State of Utah  
DEPARTMENT OF ENVIRONMENTAL QUALITY  
DIVISION OF WATER QUALITY

RE: Dump Leach No. 3 Ground Water  
Monitoring Well Network - *Final  
Determination and Request for  
Additional Monitoring Well*, Notice of  
Expiration of Authorization to Operate,  
Ground Water Quality Discharge Permit  
No. UGW450001

This letter is to convey our determinations regarding several reports required by our December 18, 1990 Conditional Approval, and to request the installation of one additional ground water monitoring well at Dump Leach No. 3.

Project: Barrick Dump 3: MW-10 = +, MW-11 = o, MW-13 = □

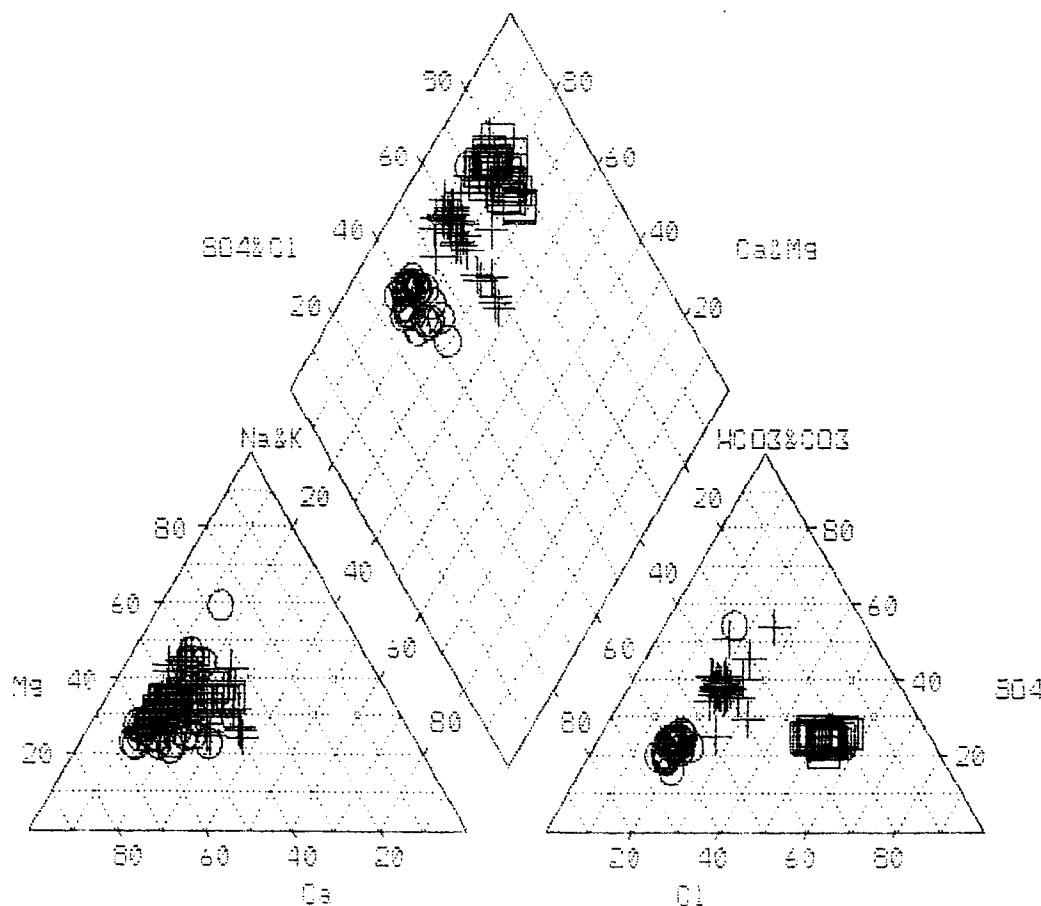
- 2) Inorganic Ground Water Geochemistry - we have reviewed 109 ground water quality samples collected by Barrick during the last two years from wells MW-10, 11, and 13, and plotted the major ion concentrations on a Piper diagram, see attachment. The results of these analyses are consistent with the earlier data which suggested that the ground water in each well has its own distinct and separate geochemical signature. Though all three wells consist of a mixture of the three major anions, well MW-11 is more bicarbonate dominant (about 60%), well MW-10 contains more sulfate (about 35%), and well MW-13 contains a significant amount of chloride (about 50%). If the aquifer was a Darcy continuum, one that has existed for millions of years having cycled its water content many times, one with relatively young ground water (less than 40 years) in it today as evidenced by tritium analysis; one would not expect such a wide variation in geochemistry over such a small horizontal distance as 1,500 feet.
